Building & Safety Division

COMMERCIAL CHECK LIST

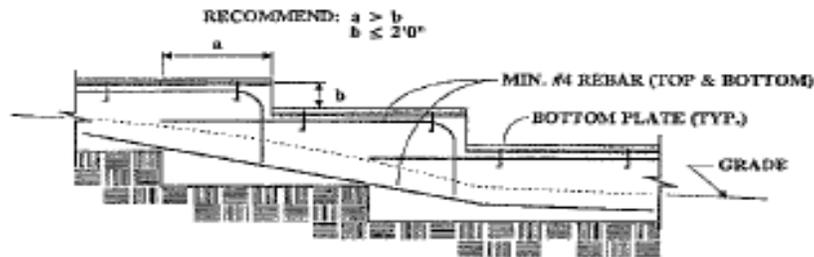
157. Detail stepped foundations on ground sloping more than 1 unit vertical in 10 units horizontal. Steps must be such that both top and bottom are level. [1808] [SMMC 8.16.030 (a)]. See detail below:
